PLANNING, ZONING, & BUILDING DEPARTMENT
PZ&B Staff Combination Memorandum: Architectural Commission and Town Council

SUBJECT: ZON-25-0007 (ARC-25-0009) 218 TANGIER AVE (COMBO)

MEETING: April 23, 2025 ARCOM
May 14, 2025 TC

Partial site plan highlighting portion of proposed addition extending beyond the permitted angle of vision.

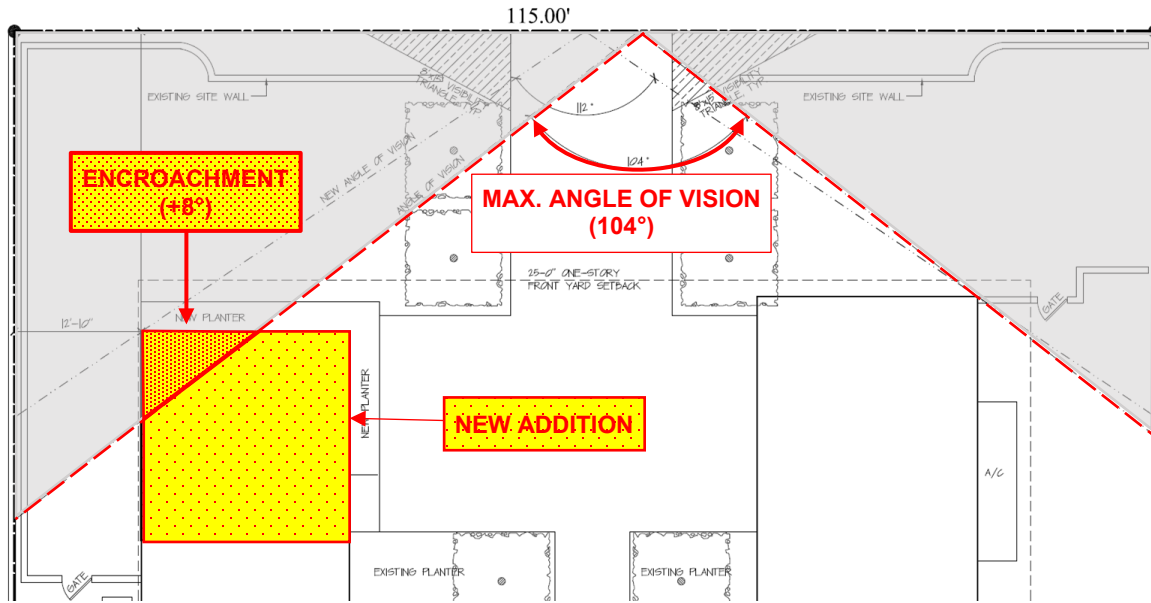
The variance required to achieve the scope of work is to exceed the permitted angle of vision permitted for the R-B zoning district. No portion of any individual building is permitted to extend beyond a line drawn from the front property line 50 degrees either side of a line drawn perpendicular or radial to the front yard property line. For lots that exceed the minimum required lot width, the base angle of vision (50 degrees on either side of the line) is increased by two degrees for each ten feet of increased lot width over the minimum up to a maximum additional width of 40 feet in the R-B district.. All structures must be sited within the angle of vision. In this application, the existing angle of vision is conforming to code at 94.5° with a maximum angle of vision of 104° permitted. However, the proposed addition will result in an angle of vision of 112° which is beyond the 104° permitted.

Code Section	Permitted	Proposed	Variance
Sec. 134-893(b)(6)d	Max Angle of Vision 104°	Angle of Vision 112°	+8°

Staff has mentioned in the past that the angle of vision regulation, designed to control mass as viewed from the street, should not apply to one-story structures and as the Town moves towards Code Reform this is one of the specific regulations that shall be critically examined.
